Service Bulletin

Bulletin No.: 19-NA-220

Subject: Loss of Propulsion, Malfunction Indicator Lamp (MIL) Illuminated - DTC P0A3F and/or P1B03 Set

5518453

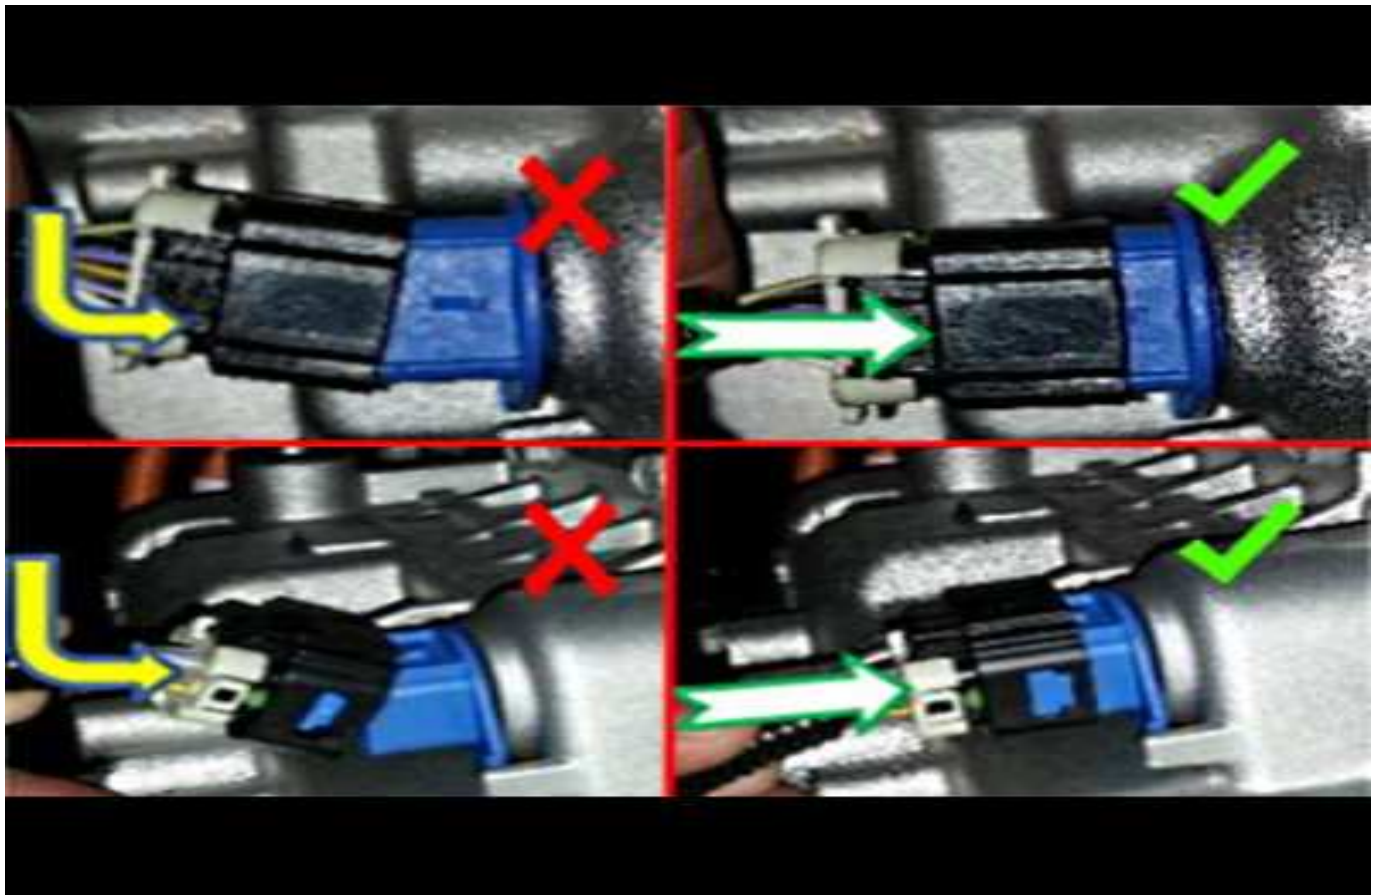
Ensure that the connector is fully seated.

5409322

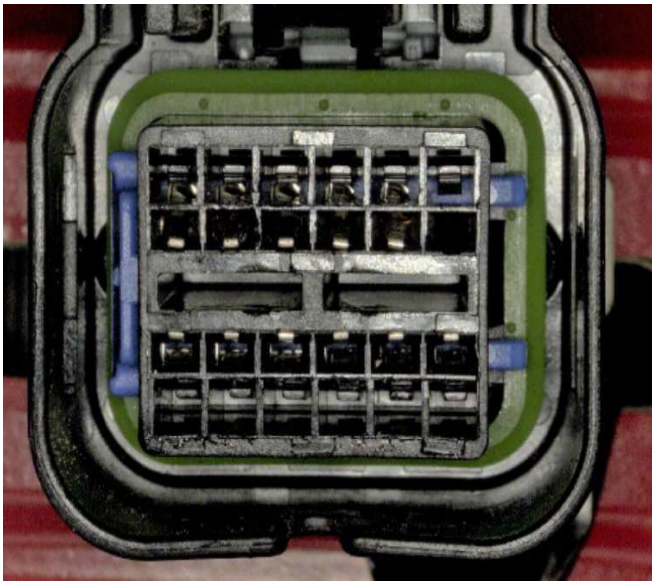
Showing both proper and improper alignment of the X2 connector.
